CHAPTER 2.0: RECOMMENDED PROJECT DESCRIPTION

2.2 RECOMMENDED PROJECT DESCRIPTION

APPENDIX C
BART EXTENSION PROJECT PRELIMINARY ENGINEERING PLANS AND PROFILES
INDEX OF DRAWINGS

Figure 2.2-1: Design Changes in Fremont

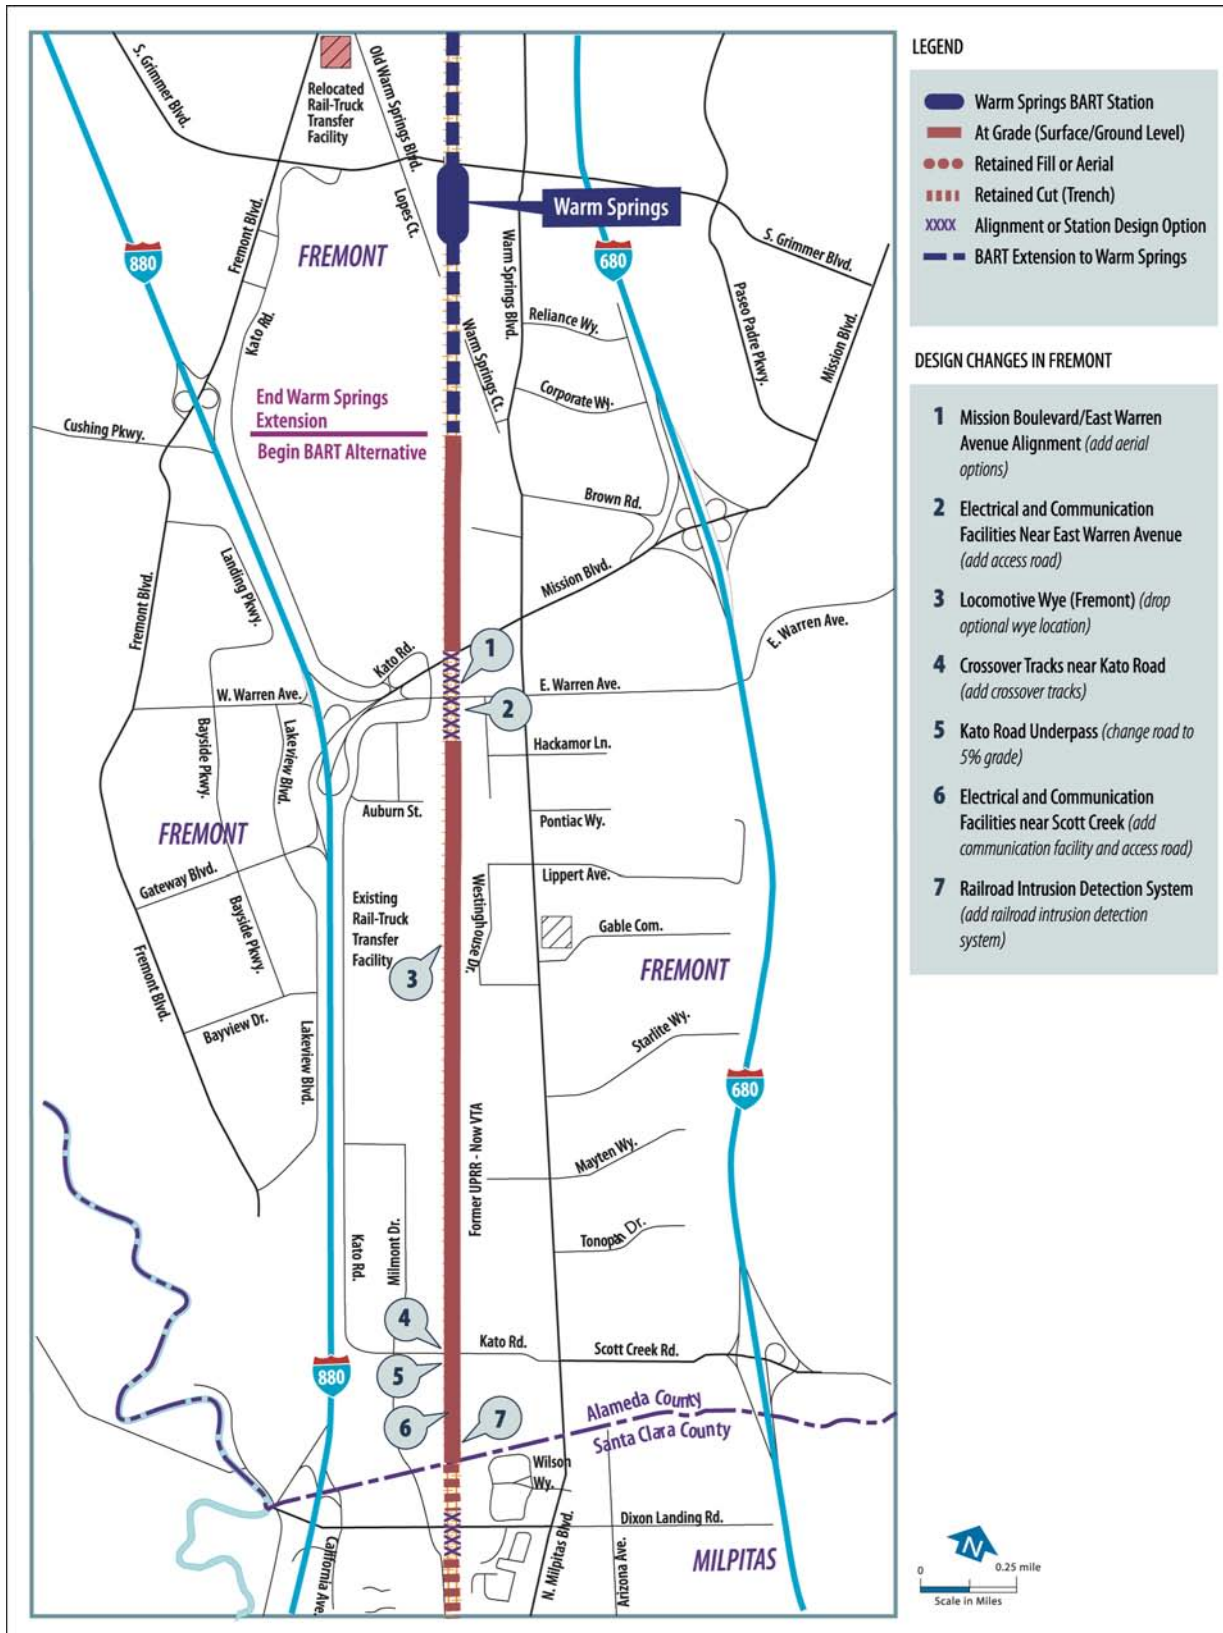
The BART Extension Project in Fremont is shown on Figure 2.2-1. The Project would begin slightly south of the planned BART Warm Springs Station in Fremont with a new, at grade, two-track BART rail line near the Union Pacific Railroad (UPRR) Warm Springs Yard (approximately 2,200 feet north of Mission Boulevard) and east of the existing railroad right-of-way

(ROW) (STA 45+00). BART would cross Agua Caliente Creek/Line F, where a new double box culvert would be constructed by VTA (STA 45+50).¹

BART would transition back into the railroad ROW south of the UPRR Warm Springs Yard (STA 60+00) and continue at grade. Other agencies would widen Mission Boulevard and reconstruct East Warren Avenue, which is currently at grade, as a new roadway underpass. BART would therefore cross both Mission Boulevard and East Warren Avenue at grade on new bridge structures that pass over these roadways. Other agencies would construct drainage improvements at Agua Fria Creek/Line D, which is slightly south of Mission Boulevard (STA 71+00).²

South of East Warren Avenue, Traction Power Substation SWA and Train Control Building S24 would be located on the east side of the railroad ROW (STA 78+50), with access provided by an easement to Mission Falls Court.

The alignment would continue at grade and cross over Toroges Creek/Line C, where a new box culvert would be constructed by others (STA 101+50). The alignment would continue past two additional culverts: Line B-1 (STA 122+00), where there are no planned improvements, and Line B (STA 146+00), where a new box culvert would be constructed by VTA.

BART would cross on a new bridge structure over Kato Road, which would be reconstructed as a roadway underpass by VTA (STA 167+00). VTA would also construct a new bridge for the UPRR to cross over Kato Road. The slope of the Kato Road underpass would be a 5 percent grade to accommodate safe stopping distances for a design speed limit of 40 miles per hour. This slope would impact access to existing driveways serving businesses immediately north of Kato Road and east and west of the alignment. These access points would be either relocated or eliminated (with other access points remaining). Single crossover tracks, which allow the passage of a train from one track to the other through the use of switches, would be constructed both north and south of Kato Road (STA 157+00 and STA 170+00). These crossovers would provide for 10-car train storage and allow single-track operations around an occasional stored train.

South of Kato Road, BART would cross over Scott Creek/Line A, where a new box culvert would be constructed by others (STA 173+00). Traction Power Substation SKR and Train Control Building S26 would be located south of the creek on the west side of the railroad ROW, (STA 175+00), with access provided by an easement to Milmont Drive.

Figure 2.2-2: Design Changes in Milpitas

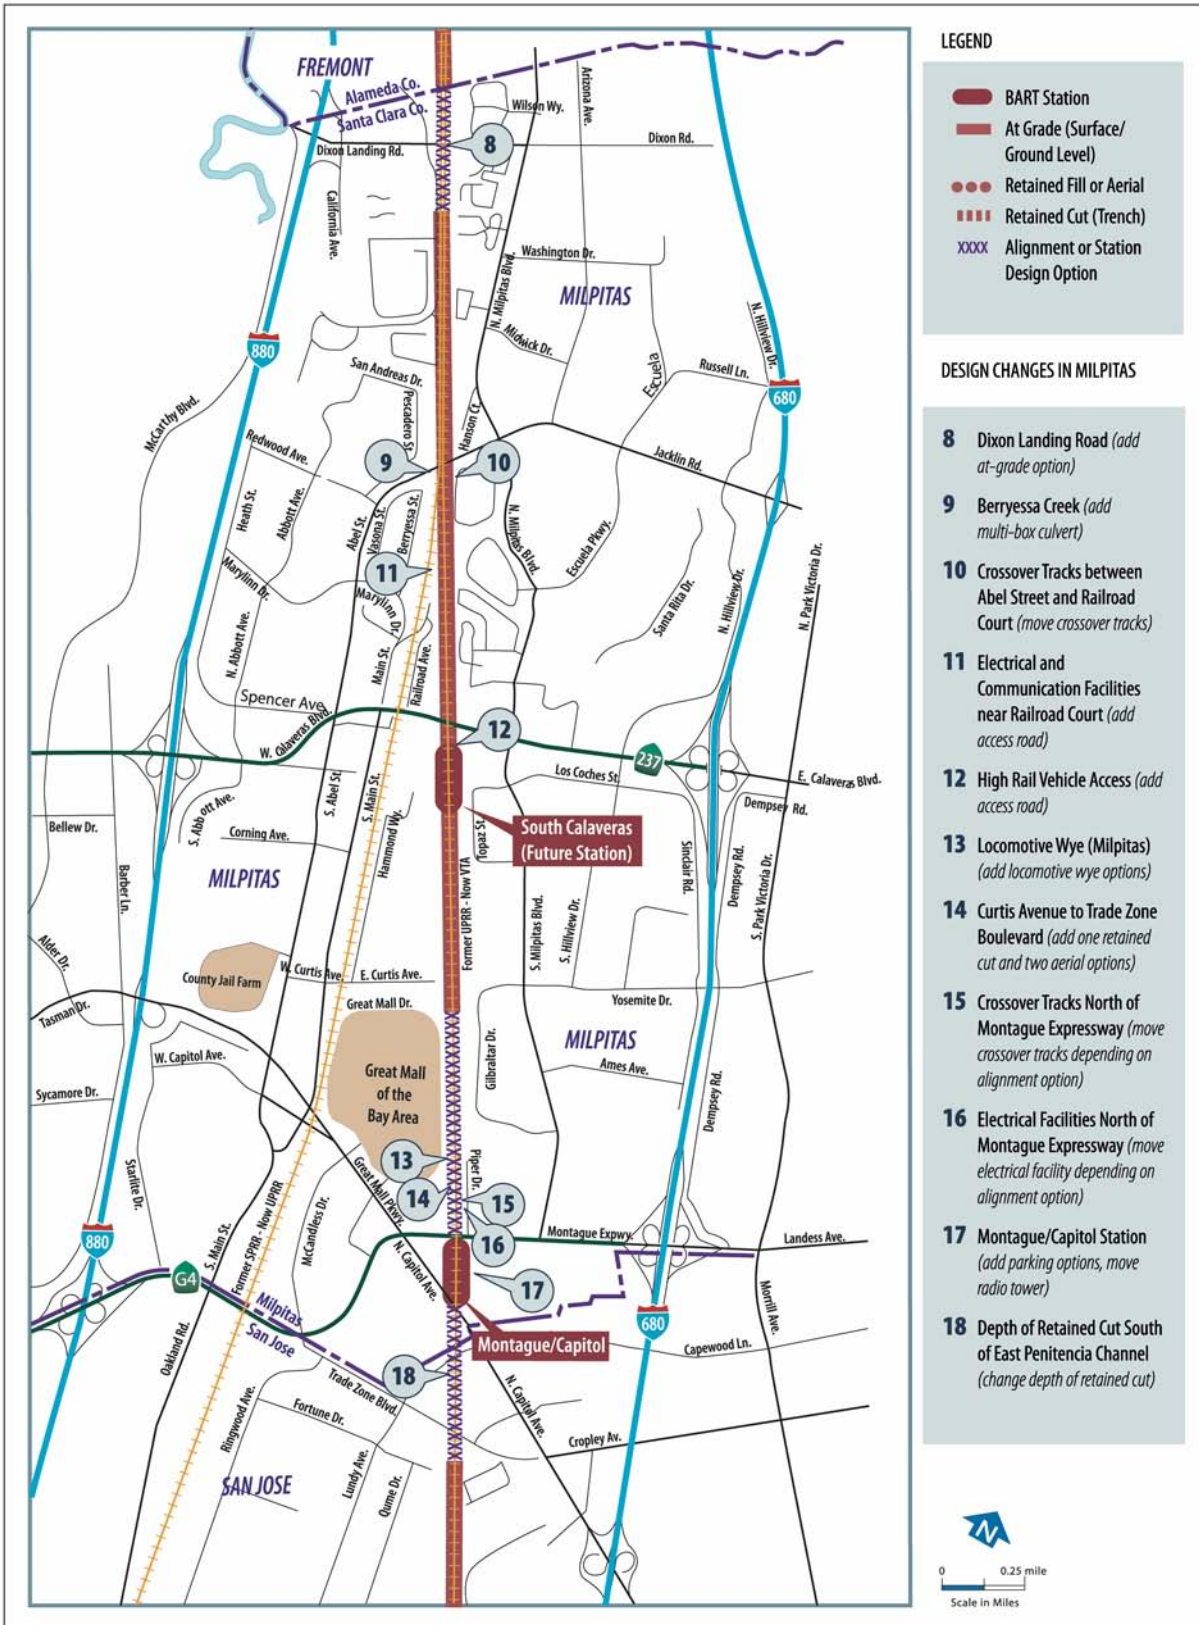
The BART Extension Project in Milpitas is shown on Figure 2.2-2. From the Alameda/Santa Clara county and Fremont/Milpitas city lines (STA 182+00), BART would continue at grade and cross on a new bridge structure over Dixon Landing Road (STA 191+50), which would be reconstructed as a roadway underpass by VTA. VTA would also construct a new bridge for the UPRR to cross over the roadway. An adjacent cross street to the west of the railroad ROW, Milmont Drive, would also be lowered due to the new slope of Dixon Landing Road. Access to two existing driveways on the west side of the alignment, with one on the north side of Dixon Landing Road and the other on the south side, would be eliminated due to the reconstruction; however, each property would have multiple access points remaining.

Approaching Abel Street, the BART alignment would cross over an existing underground culvert containing Calera Creek (STA 231+00), where no improvements are planned, and pass under the existing Abel Street overcrossing (STA 244+00). BART would continue over Berryessa Creek on a new multi-cell box culvert constructed to accommodate the widening and realigning of the creek by the Santa Clara Valley Water District (STA 246+00). Crossover tracks would be located south of this box culvert (STA 258+00).

Continuing south, High Voltage Substation SRC, Traction Power Substation SRR, Switching Station SRR, and Train Control Building S28 would be located west of the railroad ROW, with access provided from Railroad Court (STA 259+00). The high voltage substation would require installation of high voltage (115 kilovolt [kV]) power feed lines that connect to nearby existing PG&E towers/lines and/or PG&E substations. To provide 115-kV service from PG&E to High Voltage Substation SRC with adequate clearance between BART and the existing overhead high voltage power lines, a new 60-foot-high tapered tubular steel tower would be constructed within PG&E's existing easement. A second, smaller tower/pole would also be constructed to the south and on the facility site. This tower/pole would allow the 115-kV line to transition down to the substation connection.

The alignment would continue over Wrigley Creek, where a new box culvert would be constructed by others (STA+274+00), and pass under the Calaveras Boulevard/SR 237 overpass (STA 287+00). A high rail vehicle access point would be located just south of Calaveras Boulevard/SR 237, with access provided from Railroad Avenue (STA 289+00).³

Figure 2.2-3: Design Changes in San Jose

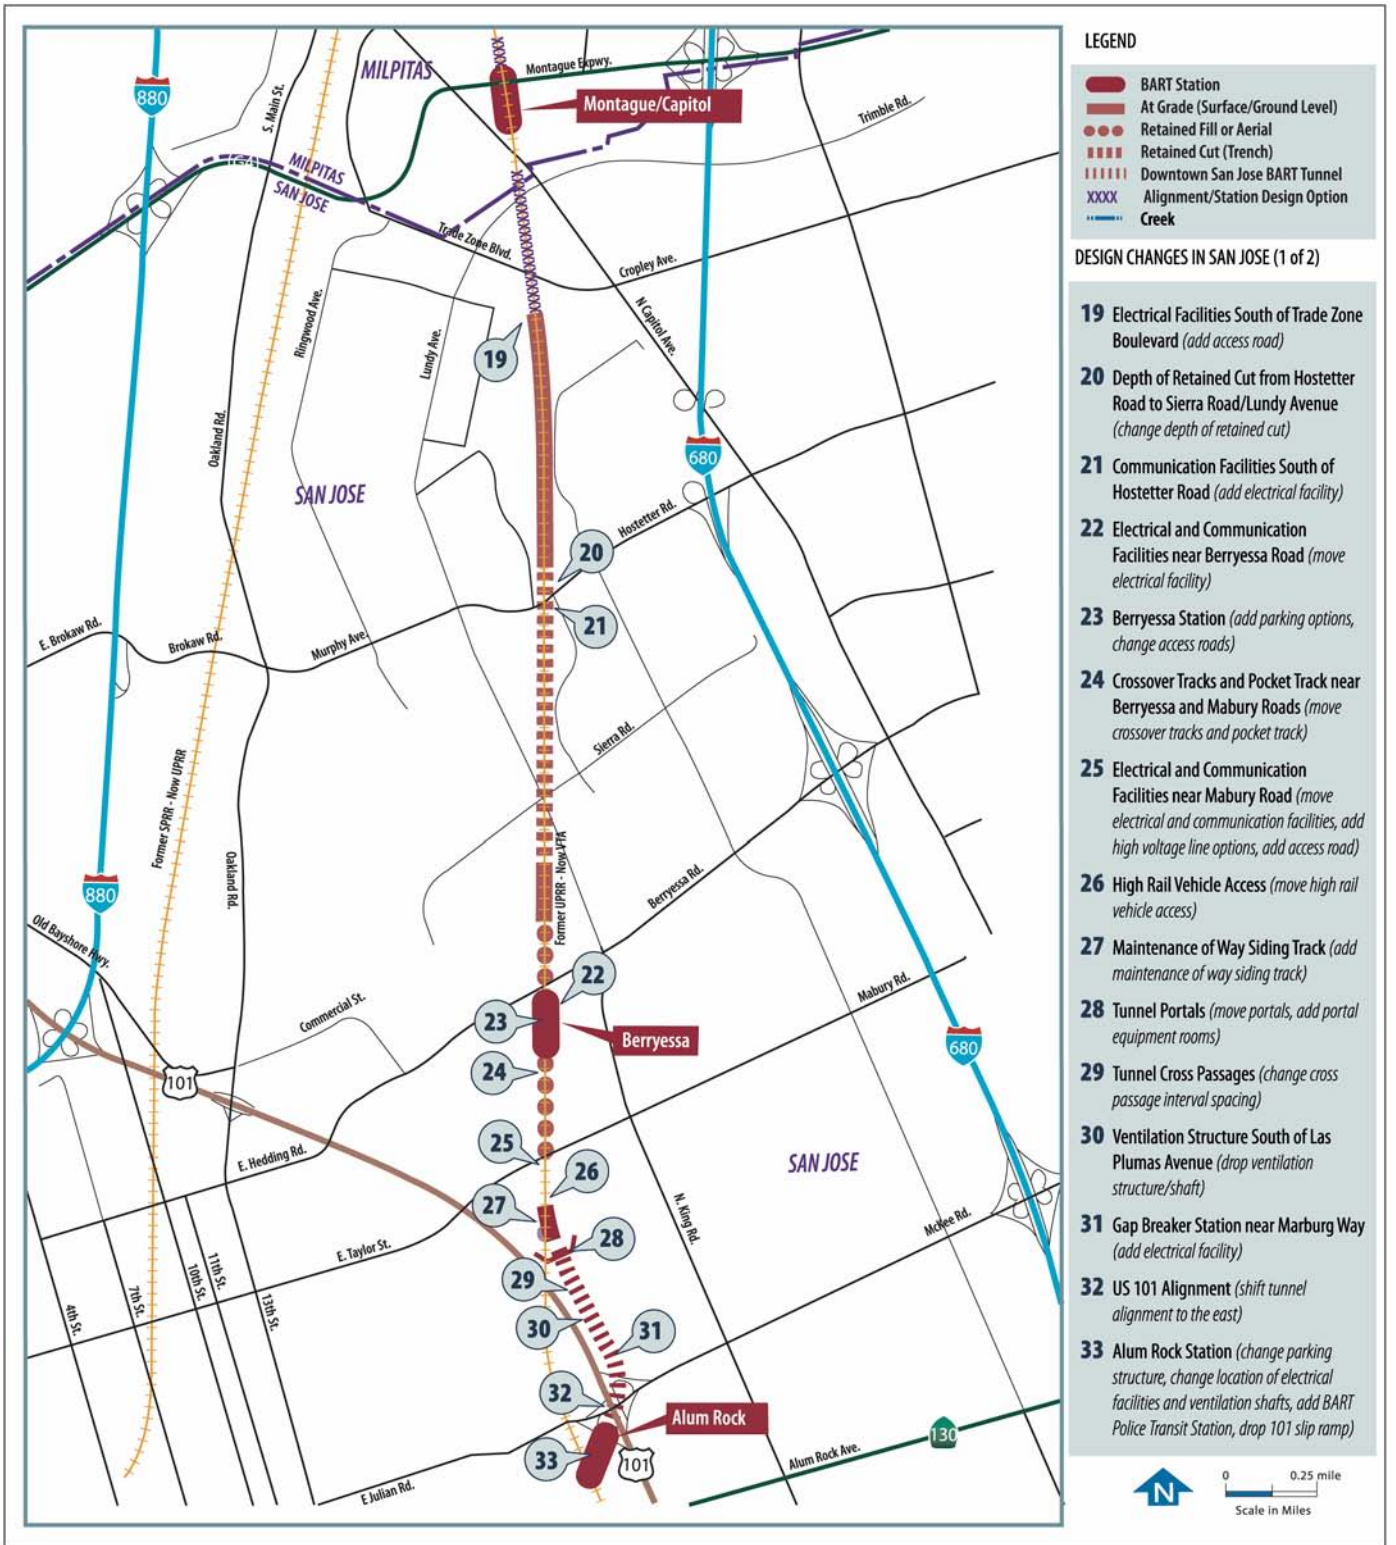
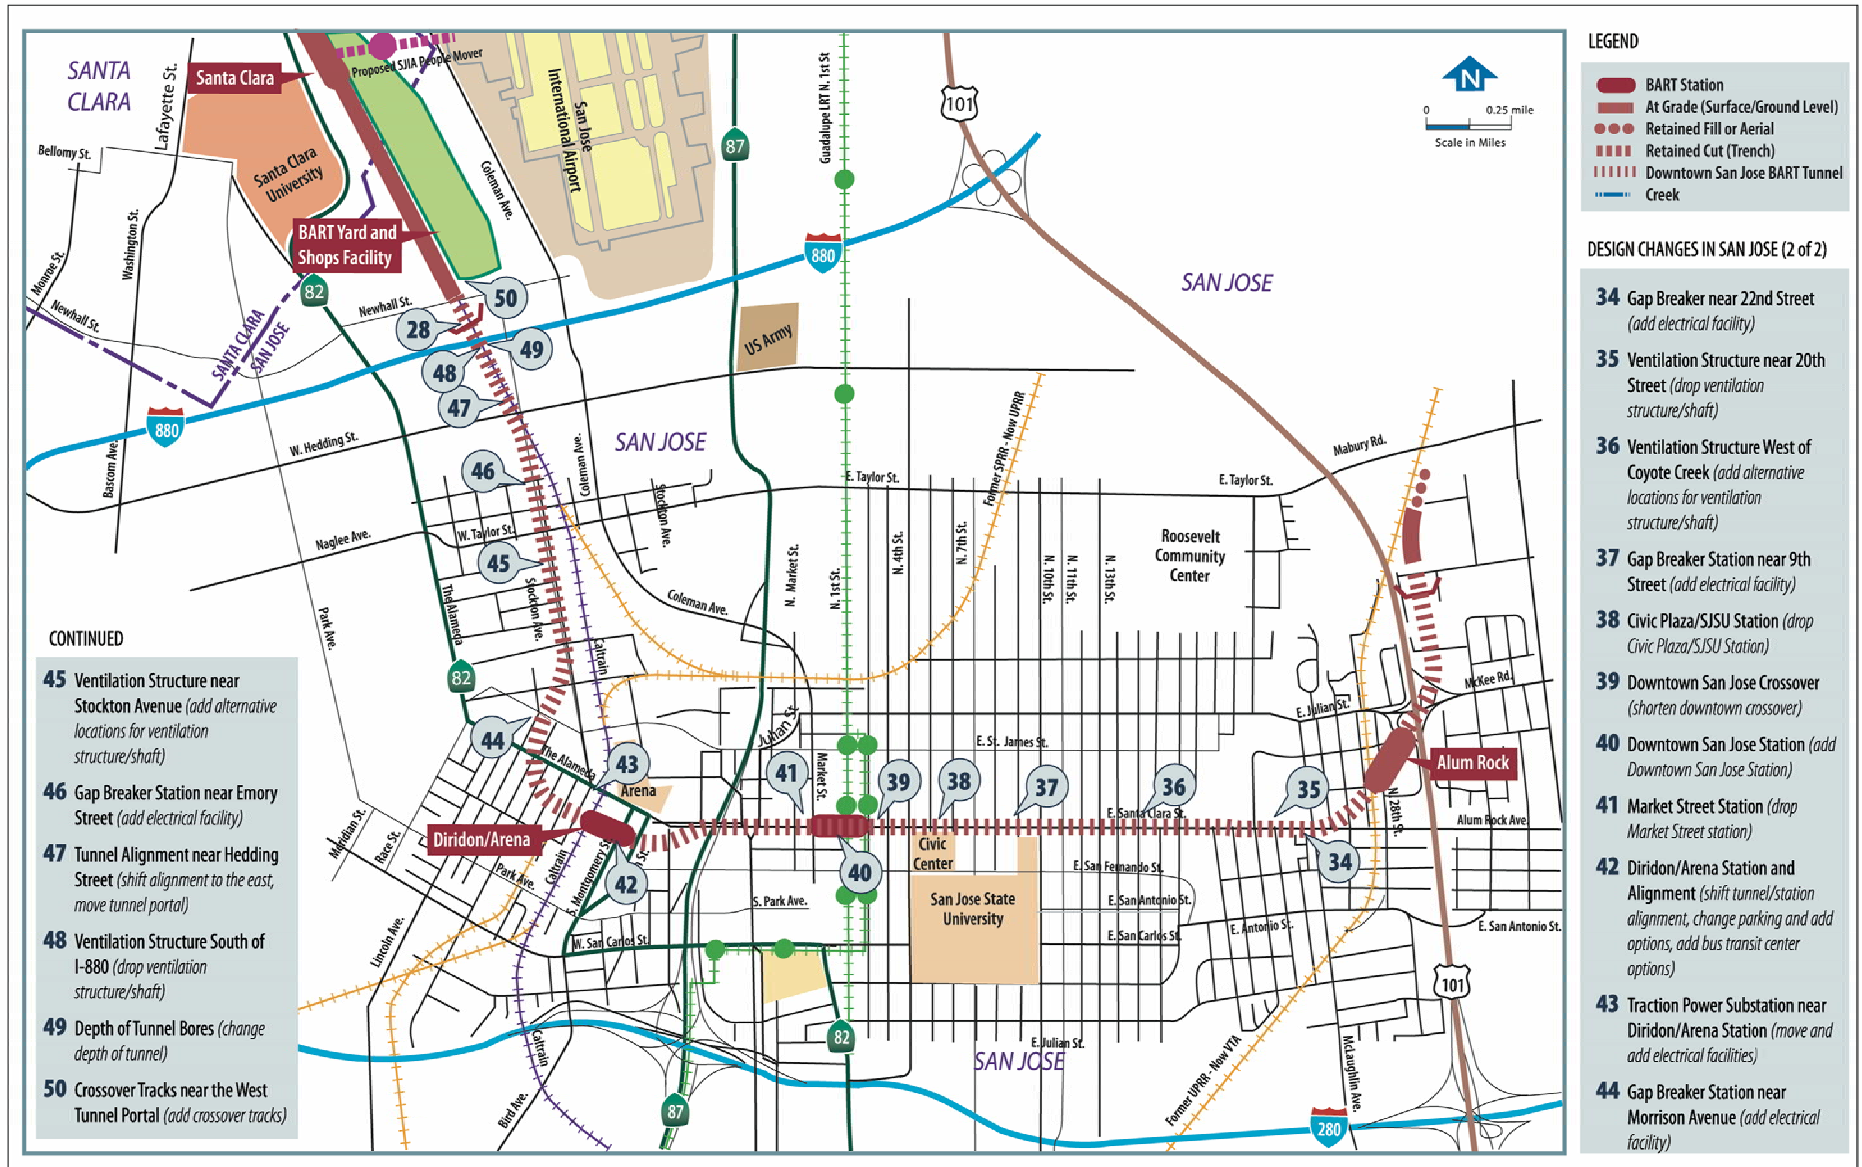
The BART Extension Project in San Jose is shown on Figures 2.2-3 and 2.2-4. BART would continue past the Milpitas/San Jose city lines in a retained cut, pass over East Penitencia Channel (STA 390+00) where VTA would construct drainage improvements, and transition to an at grade configuration south of Trade Zone Boulevard. Slightly south, Traction Power Substation SMB would be located on the west side of the railroad ROW partially within commercial parking areas (STA 416+00), with access provided by one of two optional easements to Qume Drive.

Approaching Hostetter Road, BART would transition into a retained cut. Hostetter Road would be supported above the retained cut on a new roadway bridge structure. Train Control Building S44 would be located immediately south of Hostetter Road on the east side of the railroad ROW (STA 458+00). BART would continue in a retained cut to south of Lundy Avenue and Sierra Road (STA 450+00 to 498+00). The Sierra Road/Lundy Avenue intersection, which is located at the BART crossing, would remain at grade, but be supported over the BART retained cut on new bridge structure. A maintenance access road would be constructed to the east of the BART alignment and within the railroad ROW from Hostetter Road to Sierra Road/Lundy Avenue.

South of Sierra Road/Lundy Avenue, BART would transition to an at grade configuration and then to an aerial configuration as the alignment approaches Berryessa Road. The aerial structure would pass over Berryessa Road (STA 521+00) and Upper Penitencia Creek and lead into the Berryessa Station. No improvements would be required to Berryessa Road.
